TDEC for PAM4 ('TDECQ')

Changes to clause 123, to replace TDP with TDECQ
rev 1a

26th May 2016

Jonathan King

Figure 123-4 — TDECQ conformance test block diagram

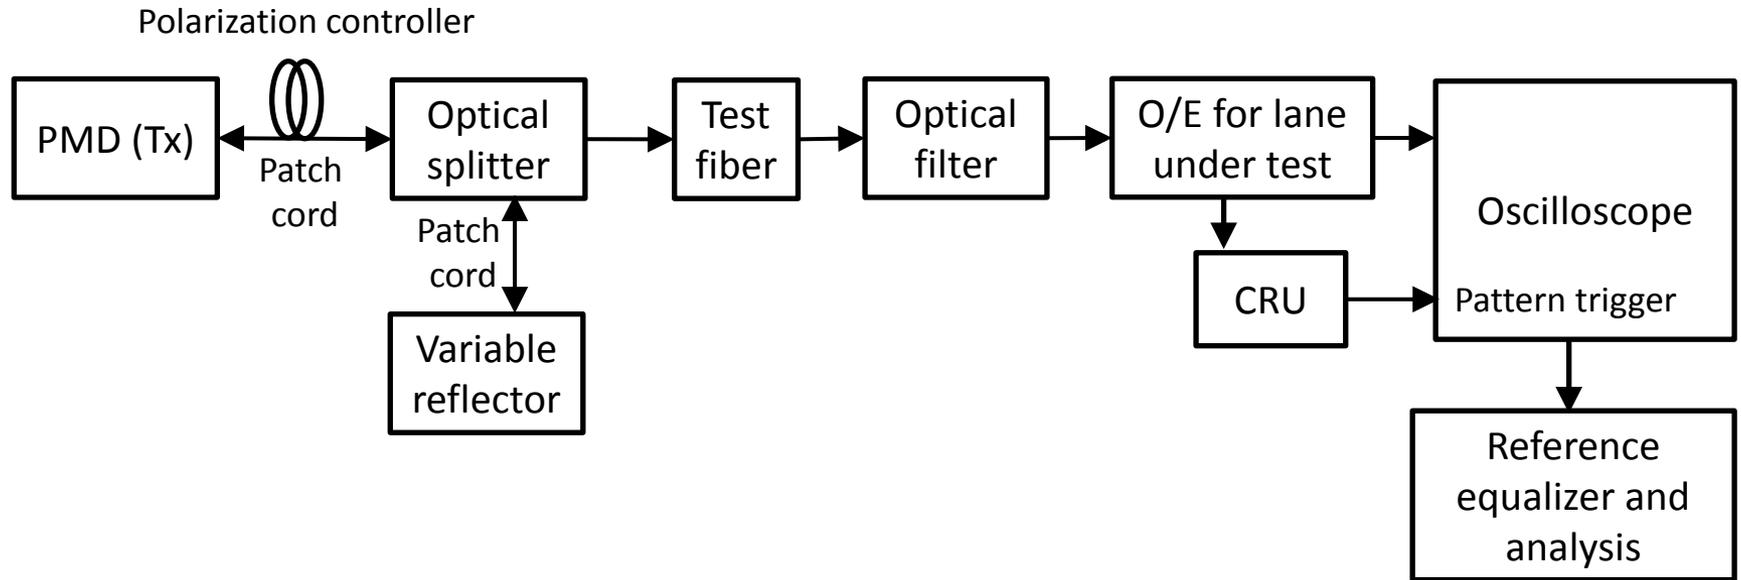
A block diagram for the TDECQ conformance test is shown in Figure 123-4. Other equivalent measurement implementations may be used with suitable calibration.

Each optical lane is tested individually with all other lanes in operation. The optical splitter and variable reflector are adjusted so that each transmitter is tested with the optical return loss specified in Table 123-12. The state of polarization of the back reflection is adjusted to create the greatest RIN. The optical filter is used to separate the lane under test from the others. Each optical lane is tested with the optical channel described in 123.8.5.2. The combination of the O/E and the oscilloscope has a fourth-order Bessel-Thomson filter response with a bandwidth of 19.34 GHz. Compensation may be made for any deviation from an ideal fourth-order Bessel-Thomson response.

JPK note: The optical filter is removed for DR4

Figure 123-5 Illustration of the TDECQ measurement

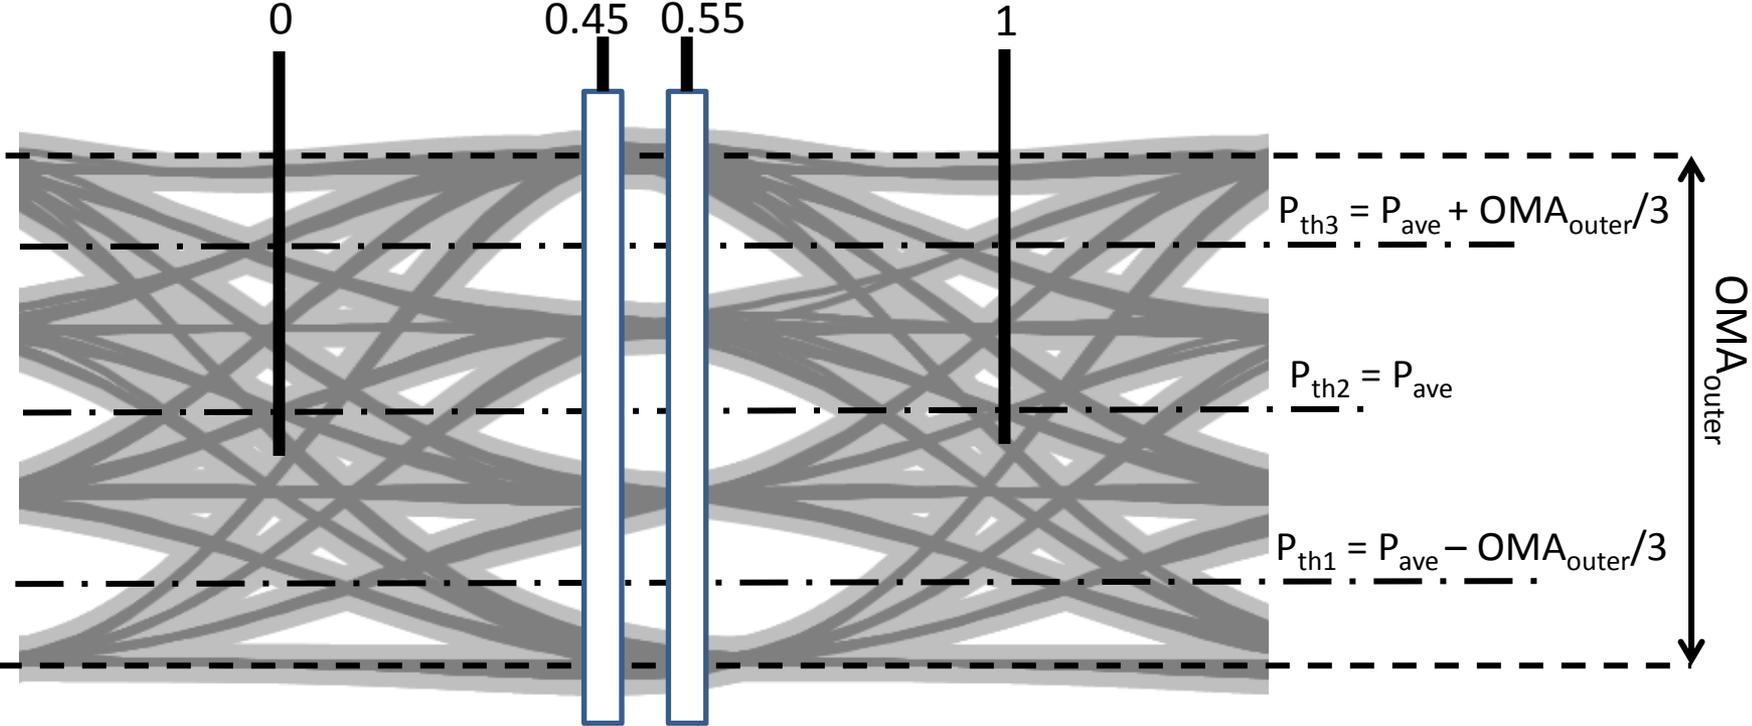
The average optical power (P_{ave}) of the eye diagram is determined, and the 0 UI and 1 UI crossing points are determined by the average of the eye diagram crossing times, as measured at P_{ave} , as illustrated in Figure 123-5.

Two vertical histograms are measured through the eye diagram, centered at 0.45 UI and 0.55 UI, each of the histograms spans all of the modulation levels of the eye diagram, as illustrated in Figure 123-5.

Each histogram window has a width of 0.04 UI. Each histogram window has outer height boundaries which are set beyond the extremes of the eye diagram (so that no further samples would be captured by increasing the vertical separation of the height boundaries).

Figure 123-6 —Stressed receiver conformance test block diagram

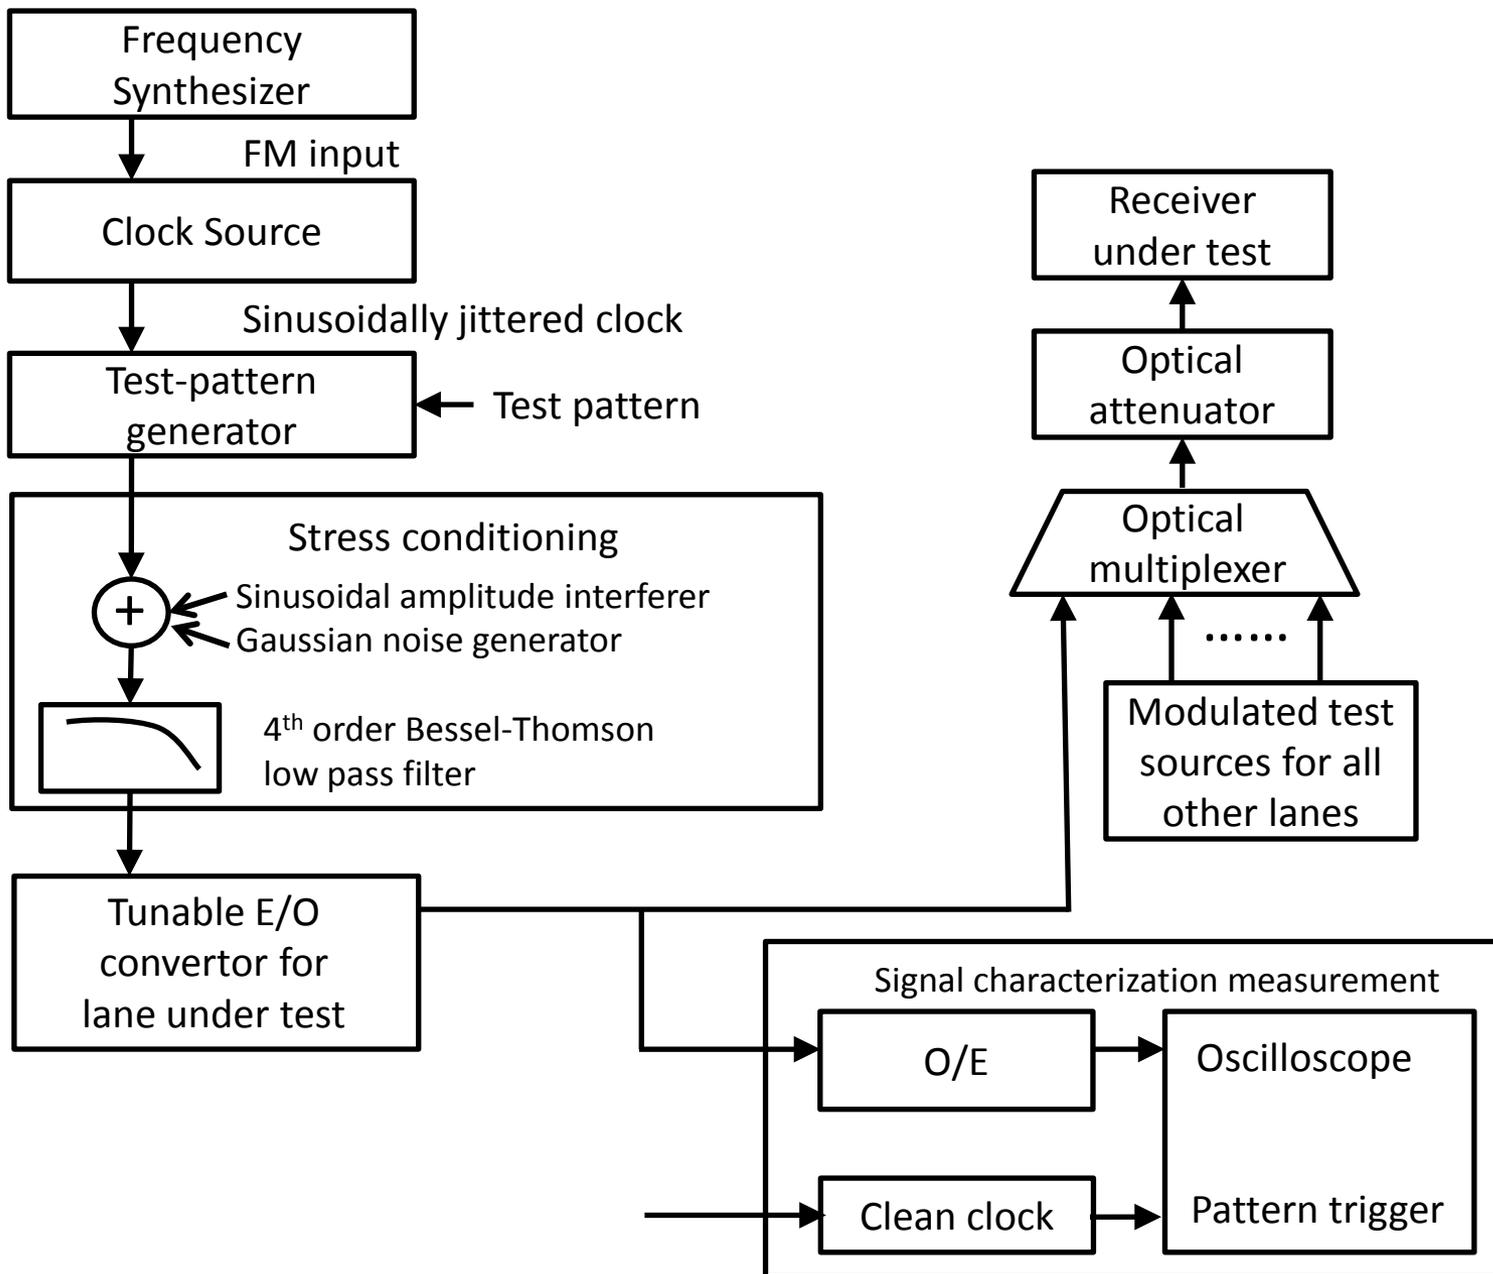
A block diagram for the receiver conformance test is shown in Figure 123–6. The patterns used for the stressed receiver conformance signal are specified in Table 123–11. The optical test signal is conditioned (stressed) using the stressed receiver methodology defined in 123.8.10.2 and has sinusoidal jitter applied as specified in 123.8.10.4.

The primary parameters of the stressed receiver conformance test signal are its stressed eye closure (SECQ), and the sinusoidal jitter applied, as specified in 123.8.10.4. The SECQ of the stressed receiver conformance test signal is measured according to 123.8.5, except that the polarization controller, optical splitter, variable reflector, and the test fiber, are not used. An example stressed receiver conformance test setup is shown in Figure 123–6; however, alternative test setups that generate equivalent stress conditions may be used.

The following steps describe a possible method for setting up and calibrating a stressed receiver conformance test signal when using a stressed receiver conformance test setup as shown in Figure 123–6:

Figure 123-7 Illustration of the mask of the sinusoidal component of jitter tolerance

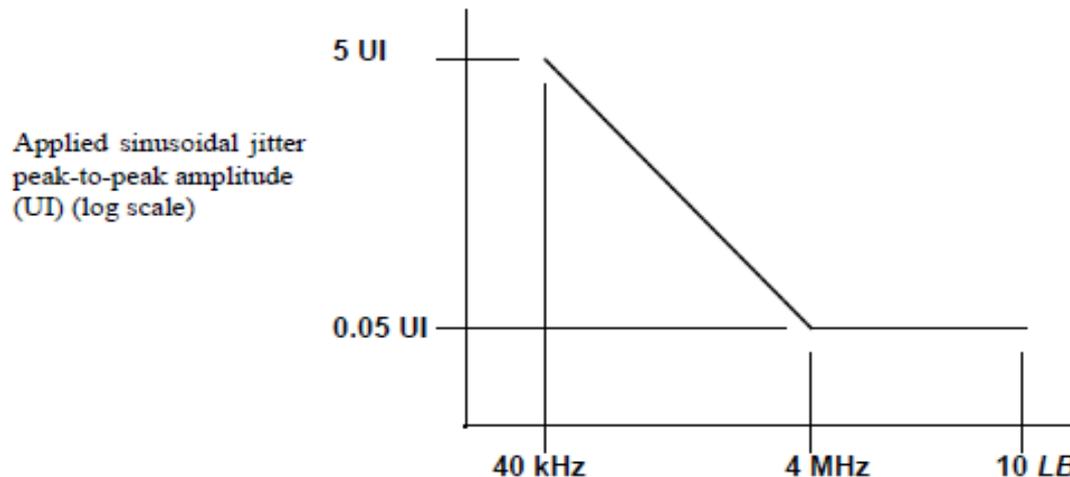
The sinusoidal jitter is used to test receiver jitter tolerance. The amplitude of the applied sinusoidal jitter is dependent on frequency as specified in Table 123–13 and is illustrated in Figure 123-7.
